Modification Declaration

Quemlink Wireless Solutions Co., Ltd.

Quemlink Wireless Solutions Co., Ltd. respectfully requests class II permissive change for FCC ID: YQD-GL53MG.(original Grant date: 01/23/2022)

Figure 2. The GL53MG Plus

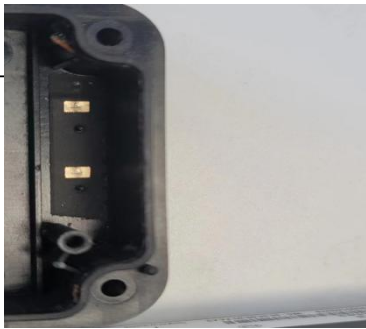
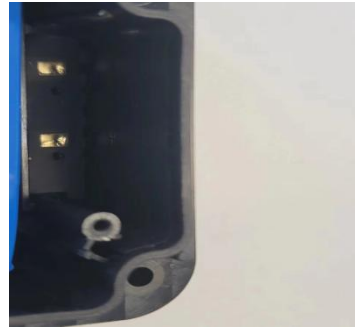
- Add series model GL53MG Plus
- Replaced 4400mAh battery for GL53MG Plus GL53MG uses 2400mAh battery.
- Change the same type antenna for GL53MG Plus.

Figure 2. GL53MG Plus

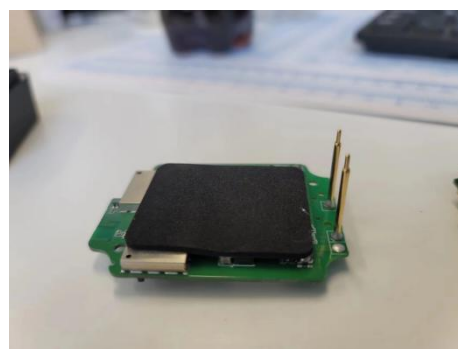
- Compared with GL53MG, GL53MG Plus has thicker backshell, longer antenna thimbles and one less thimble.
